March 12, 2018

Re: Scoping Comments for the Brooklyn-Queens Expressway Atlantic  
to Sands Reconstruction Project

### Southbound BQE interchange (proposed redesign)

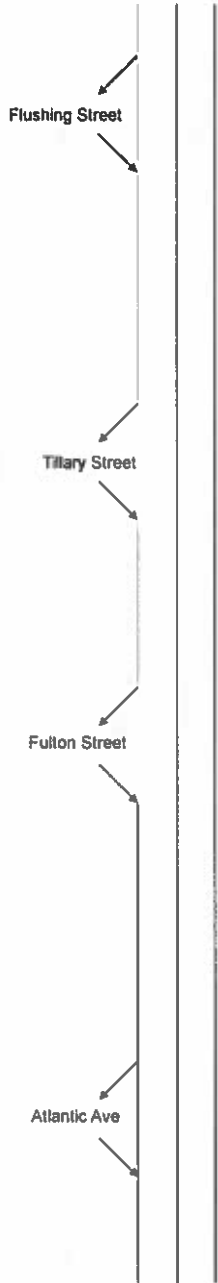
The Brooklyn-Queens Expressway southbound exit and entry for Atlantic Avenue is at the end of an descending curve as traffic enters the viaduct leading to the Gowanus Expressway. Traffic entering the southbound lanes have no acceleration space, and must generally come to a full stop, then accelerate quickly. Visibility of oncoming traffic is extremely limited. This creates safety issues, and delays traffic entering the highway.

I propose that the outer lane of the southbound BQE be converted to an exit-only lane for traffic exiting to Atlantic Ave/Columbia St. The outer lane south of the interchange would be converted to an entry/acceleration lane.

Through traffic entering the southbound BQE at Fulton Street (primarily from the Brooklyn Bridge) would need to change to the center or inner lane over the 1 mile (approx.) distance between interchanges. However this is the same traffic pattern that exists at several points in Downtown Brooklyn (the outer lane south of Flushing St becomes an exit-only lane at Tillary Street, followed by an entry lane which becomes an exit-only lane at Fulton Street)
